TO: PLANNING COMMISSION

**FROM: LISA ANDERSON-OGILVIE, AICP
DEPUTY COMMUNITY DEVELOPMENT DIRECTOR AND PLANNING
ADMINISTRATOR**

**SUBJECT: APPEAL OF PLANNING ADMINISTRATOR DECISION ON PARTITION
CASE NO. PAR20-13 FOR PROPERTY LOCATED AT 4204 KURTH
STREET S**

(Directly below: looking East on Warren St, property out of frame, and showing where street narrows and why)

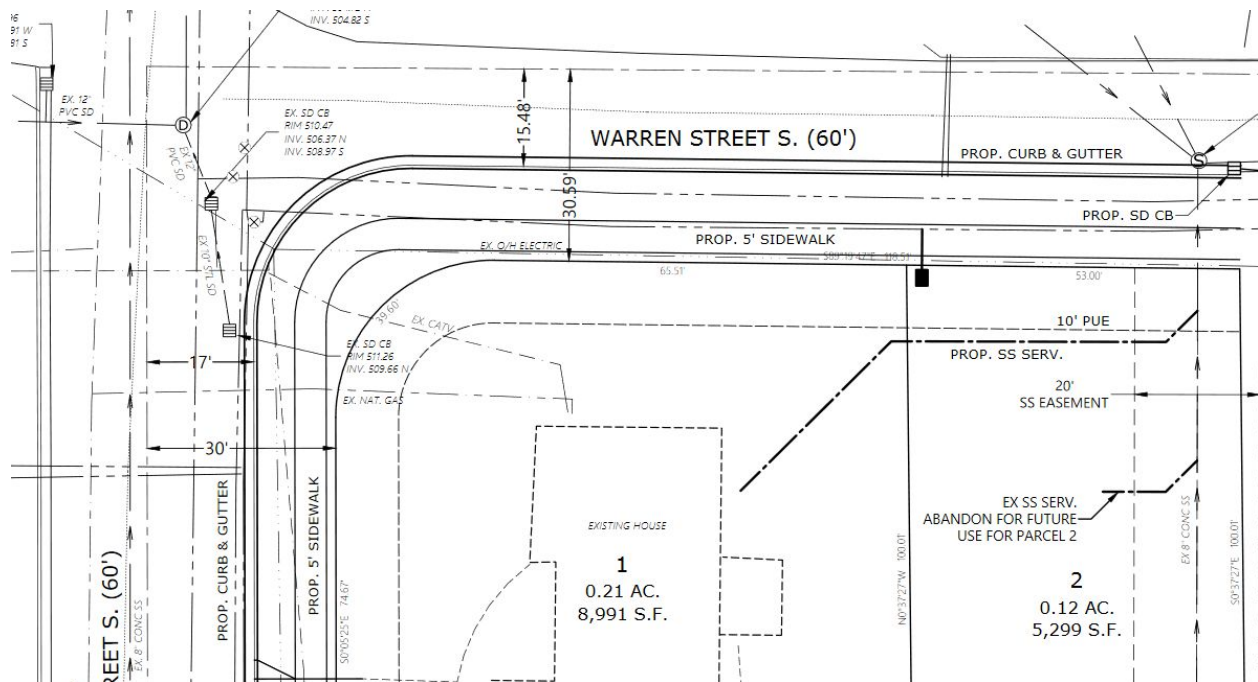
The narrow portion of Warren Street spans the entirety of the property frontage for this proposed development. The applicant's appeal includes a proposed site plan. To put a curb and gutter directly next to the narrow portion of Warren Street would not allow for:

1. Two lanes of traffic that are twelve feet wide as required by SRC and UTDC, for the site plan states that it will be little more than fifteen feet in total street width adjacent to the property.
